LETTER REPORT
CULTURAL RESOURCES COMPATIBILITY ANALYSIS
SOUTH CAMPUS HOUSING

FINAL REPORT
September 27, 2018

Figure 6: Phase One Elevations

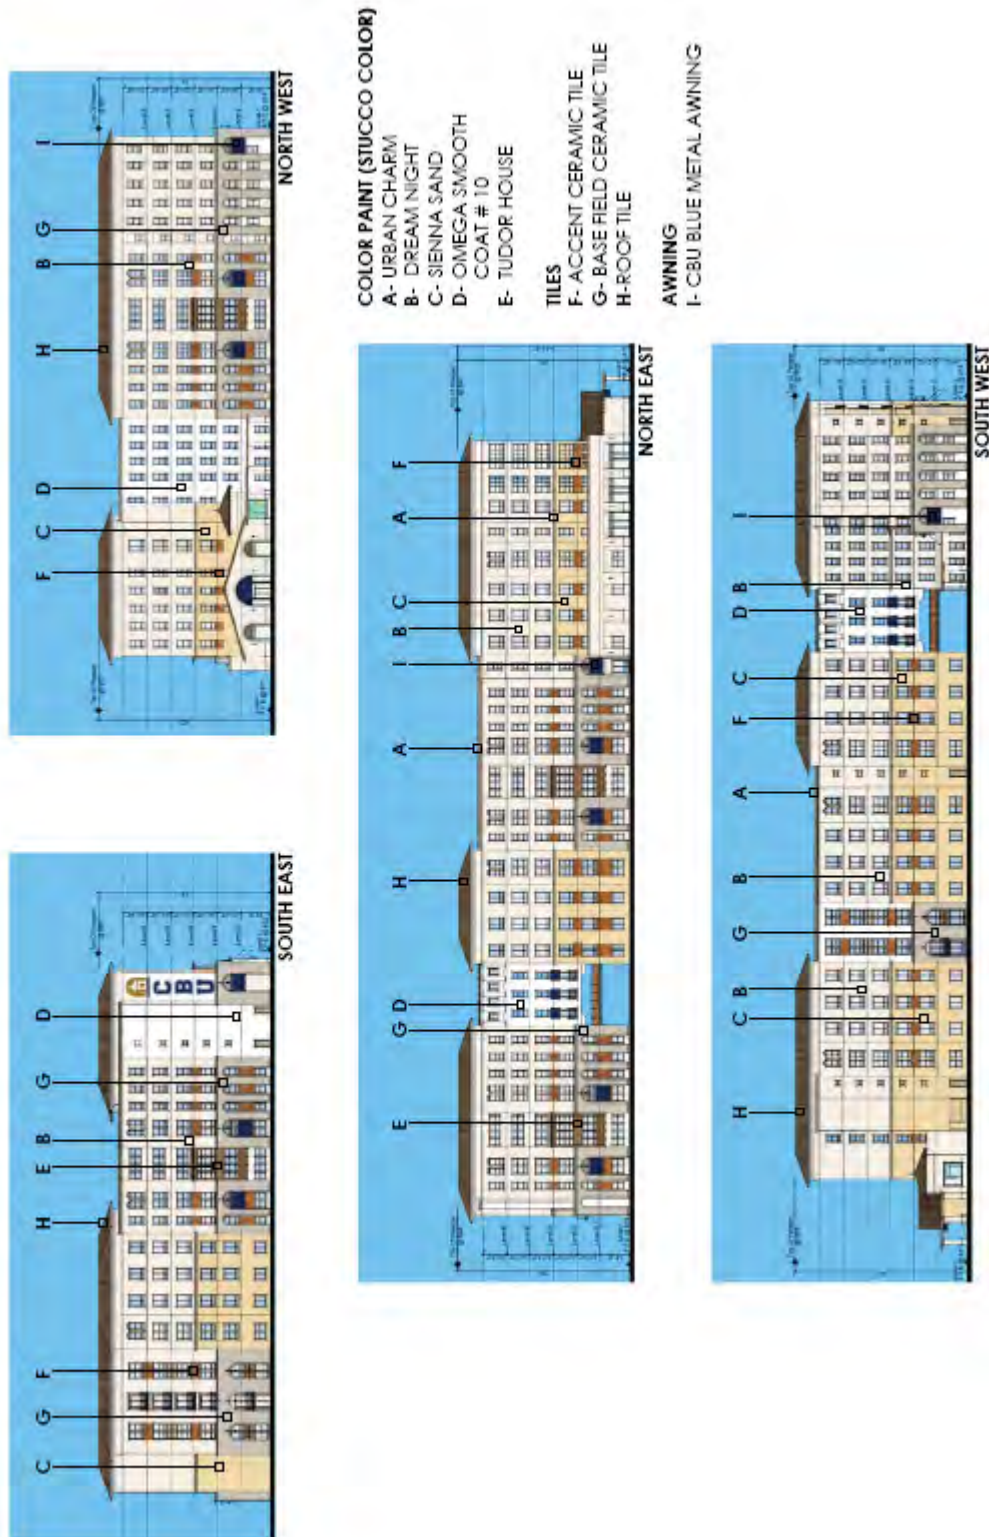
This proposed project is divided into two phases, both in the vicinity of Smith and Simmons Halls. As Phase Two is not proposed for implementation at this time, this report only addresses the impacts of Phase One on Smith and Simmons Halls. Smith Hall is a two wing, three-story building for male students. Simmons Hall is a four wing dormitory for women, and consists of both two and three-story wings. Figures 1 and 2 are contemporary views of Smith Hall, while Figures 3 and 4 are contemporary views of Simmons Hall. Figure 5 is a site plan view of the proposed buildings in relation to Smith and Simmons Halls. Figure 6 contains elevations of the proposed Phase One building, and Figure 7 is a color and material board.

Response: The architect had two major design challenges to consider in the architecture of the new dorm building. On one hand, the architect was charged with designing a building that complied with the California Baptist University’s Design Guidelines. These guidelines address a number of design considerations, all of which tend to point to various interpretations of a Post-Modern Spanish Colonial Revival design theme. The architect was also charged with designing the new building in a manner that would be respectful of the existing Smith and Simmons Halls. We believe he has achieved these objectives admirably. As noted earlier, the existing Smith and Simmons Halls are Mid-Century Modern in design, with the proportions, massing, scale, and relation of solid to open elements typical of buildings designed in the 1960s. It would have been inappropriate to design the new dorm to mimic the existing Smith Hall. In fact, the Secretary of Interior Standards/Guidelines discourage such an approach. The architect’s use of rich colors, textures, and materials in the first three stories is designed to facilitate compatibility between the new dorm and the existing Smith Hall. Replication of the architecture of Smith and Simmons Halls has been avoided, as recommended by the Secretary of Interior; however the colors, textures, and materials chosen for the first three stories directly relate to these existing dormitories. That said, we have identified one area where compatibility between the new dorm and the existing dorms can be improved. The stair towers on the existing dorms are bold vertical design elements that are visually distinctive. We believe the use of a uniform darker color on the two stair towers of the new dorm would help further strengthen the compatibility of the new dorm with the existing dorms. As we envision it, this color would be applied to the entirety of the stair towers, from bottom top.

That the existing design of the new dorm building be approved as submitted, with the exception of the stair towers, which will be painted a darker color.

Figure 15: 1967 Cowan and Bussey Master Campus Plan

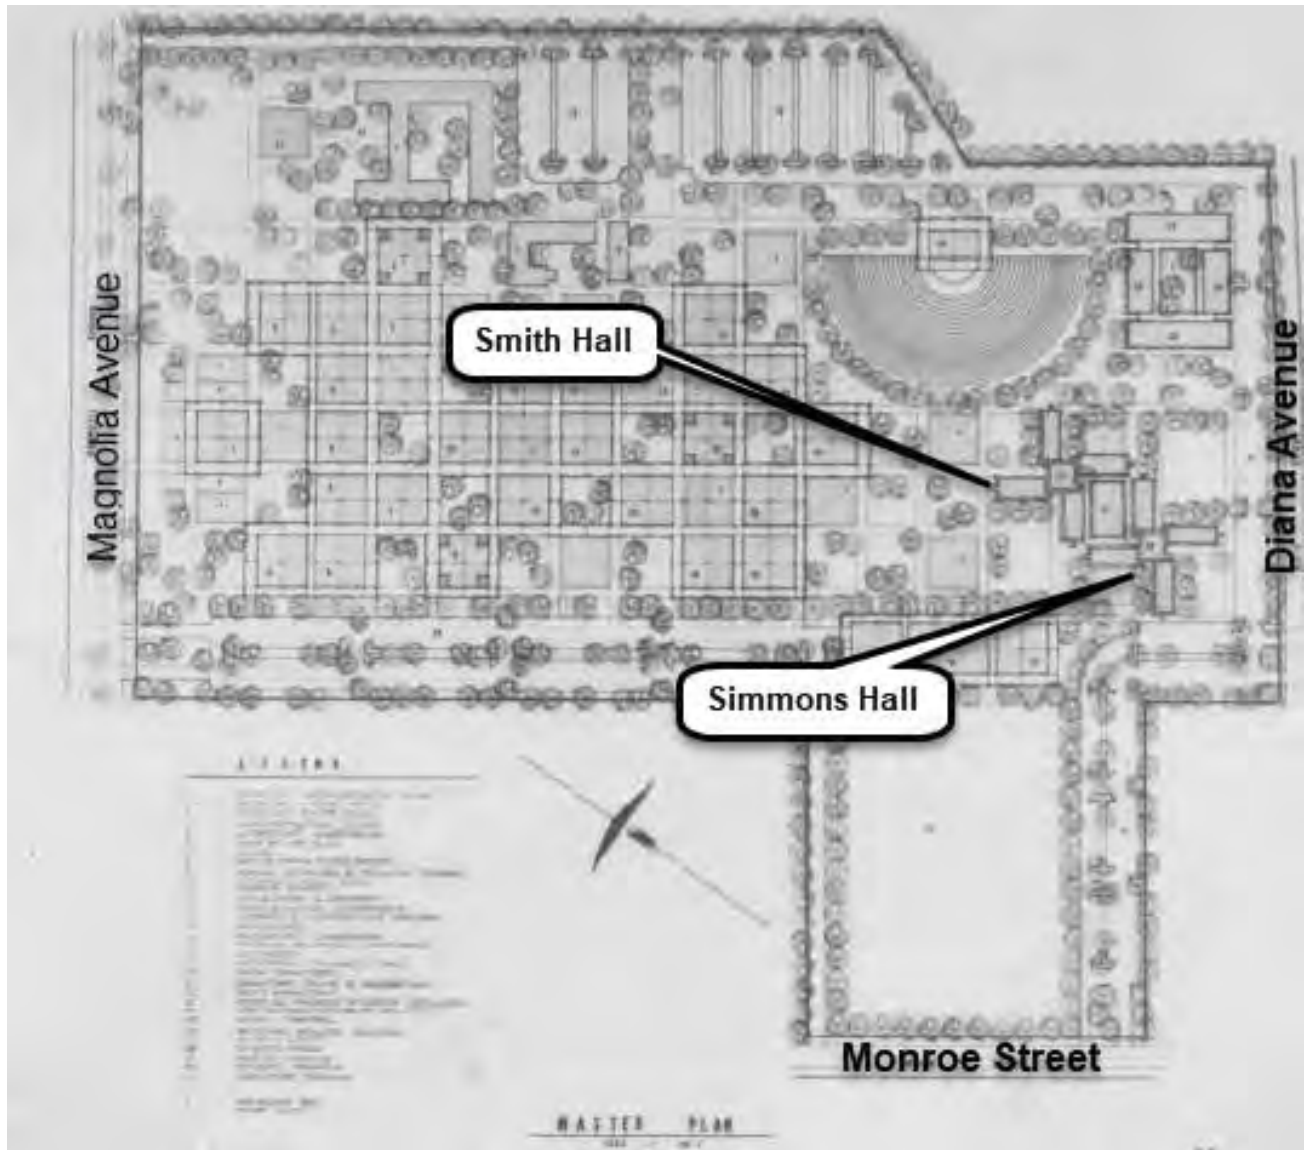
Figure 15 at the back of this report is a site plan showing the full planned extent of the two residential halls as components of the 1967 Campus Master Plan. Each dorm complex was originally designed to include both two- and three-story wings. While Simmons Hall was completed in this full cross-axial form, only half of Smith Hall was completed, consisting of two three-story wings. Figure 16 contains historic photos of these two residential halls soon after their completion in 1968.
